BURLINGTON DEVELOPMENT REVIEW BOARD Tuesday June 7, 2016 PUBLIC HEARING NOTICE

To: Development Review Board
From: Mary O'Neil, AICP, Principal Planner
Date: May 3, 2016; deferred to 6/7/2016
RE: ZP16-0888CA; 100-102 North Union Street

TO: Development Review Board
FROM: Scott Gustin & Mary O'Neil, Principal Planners
DATE: June 7, 2016
RE: 16-1183SP; 311-375 North Avenue

Parking area

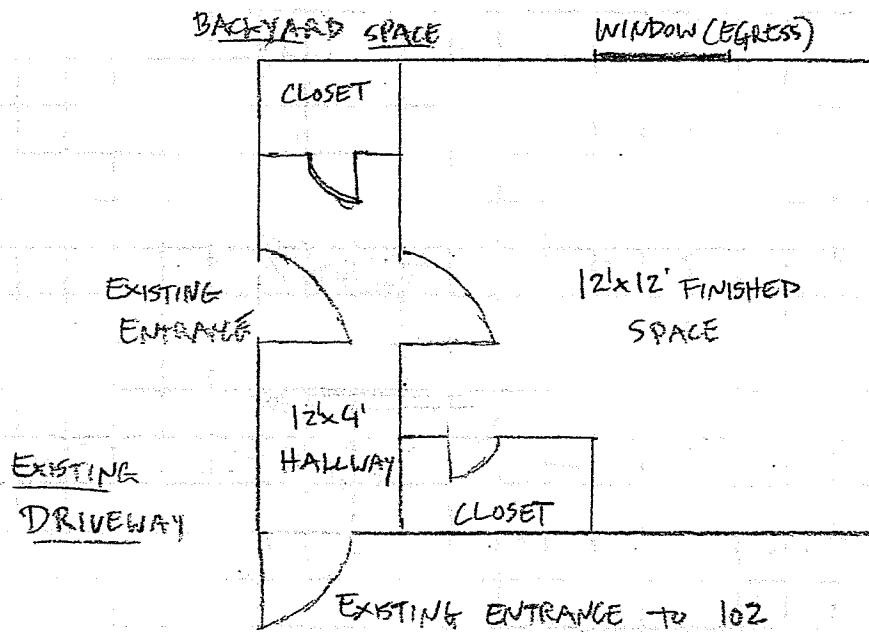
The proposed parking plan on the submitted site plan does not meet the required 5' minimum side yard setback. **Adverse finding.**

2. Scaled plan appears inaccurate (site plan scales lot width as 61'; tax maps identify lot width as 56.32'). No survey was provided to confirm parking adequacy or required setbacks on the parcel. **Adverse finding.**

The applicant provided a site plan drawn 1"=10'; however there appear to be inaccuracies. The lot per tax and assessor's records is 56.32' wide while the site plan illustrates the width in excess of 60'. A concrete pad that surrounds the north side of the house is not illustrated, nor are the utility meters with protective bollards. On-site measurements define lot width between the concrete walk and the first (westerly) bollard as 11.8'; the width measurement between the walk and the 2nd bollard as 12.25'; not the 20' illustrated.

The bollard-protected utility meter restricts full width parking on the south of the driveway, the bollard and chain on the north. The location of the northerly property boundary is not known. These measurements are inconsistent with the submitted site plan, which was presented as "existing driveway/parking." **Adverse finding.**

The site plan prepared by the applicant indicates a building footprint of 2110 sf and an "existing driveway" of 70' x 20'. The total area (excluding walkways) is 3510 sf, or 66.71% lot coverage. This exceeds allowable base coverage for the zoning district of 40%.

The parking area/driveway is illustrated on the site plan as up to the northerly (side yard) property line. There is not sufficient evidence that this is a preexisting nonconformity, and therefore presents an encroachment into a required sideyard setback. The applicant did not present a survey to support the accuracy of his plan. **Adverse finding for coverage and setback compliance.**

The site plan submitted by the applicant omits a setback from the side (north) property line, and therefore presents an encroachment into a required side yard setback. **Adverse finding.**

2000 Aerial Photo from Vermont Archives, shows one car in shadow of building and one next to

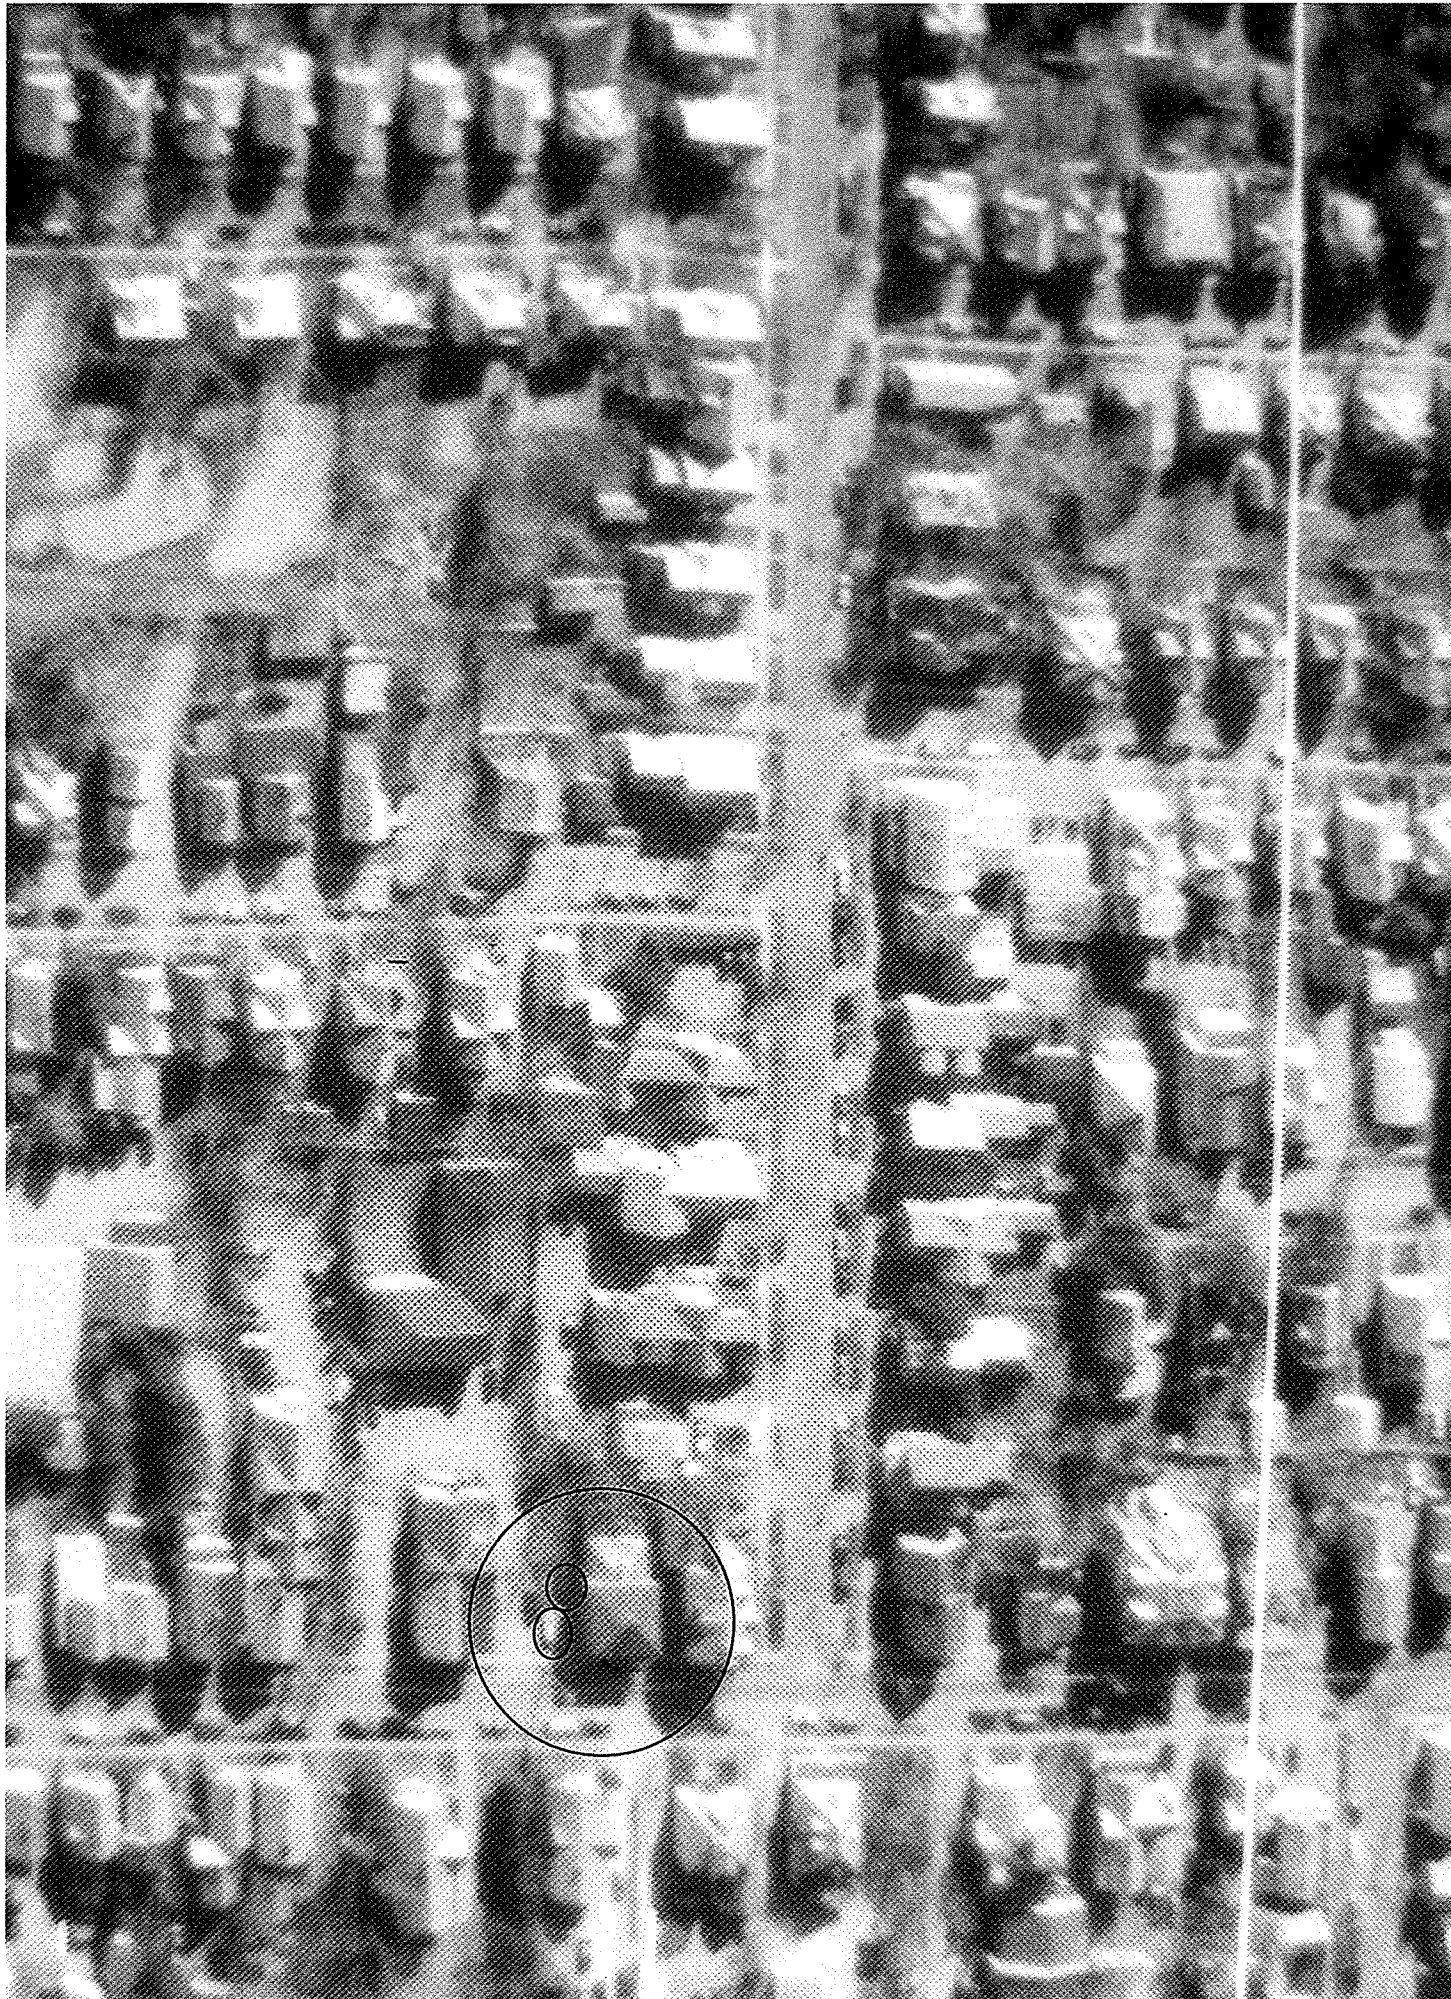
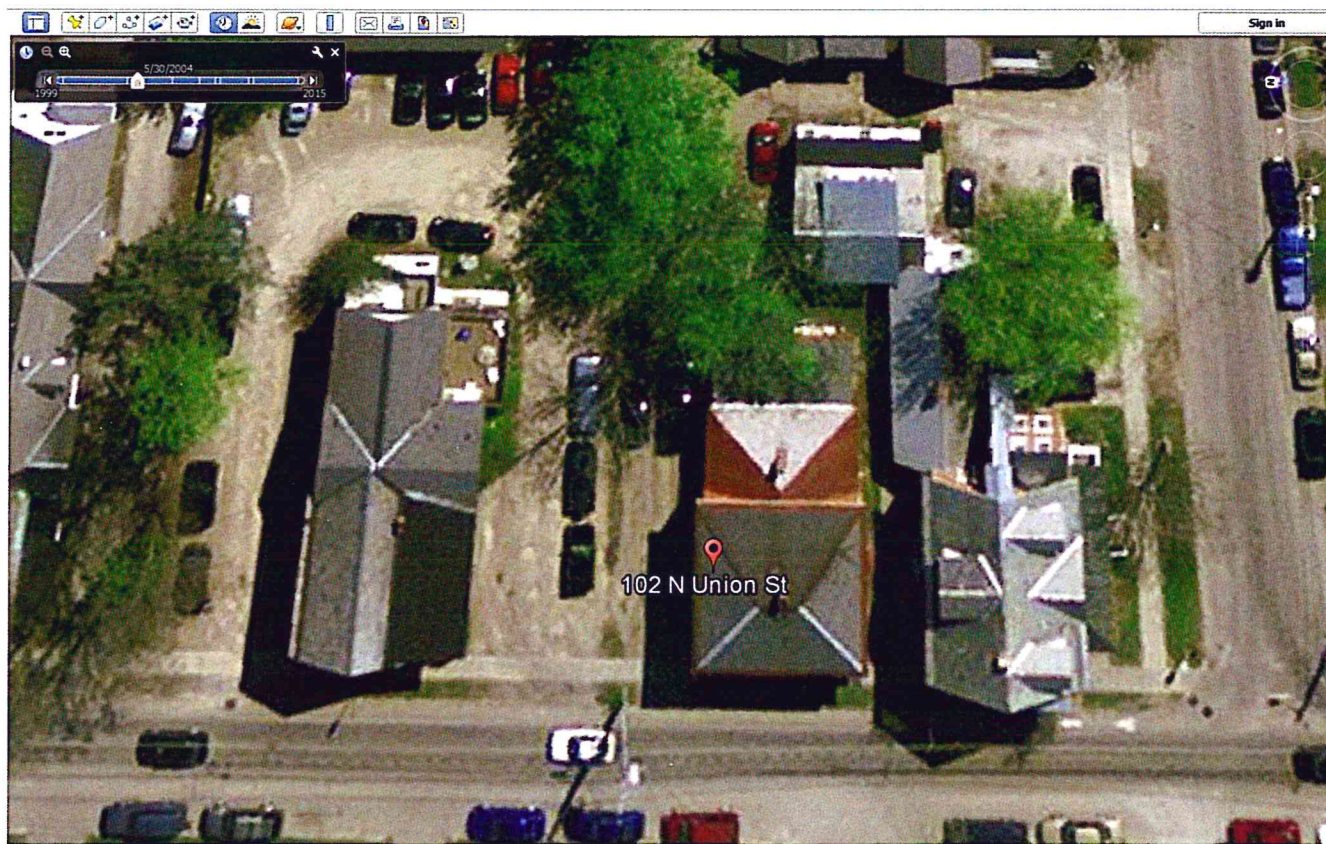
The applicant submitted a detail copy of a 2000 aerial photograph where he asserts adequate parking is represented. The photograph does illustrate vehicles in the driveway, but they are “off-set” from each other; staggered within the access drive and therefore not representative of the parking plan submitted as pre-existing.
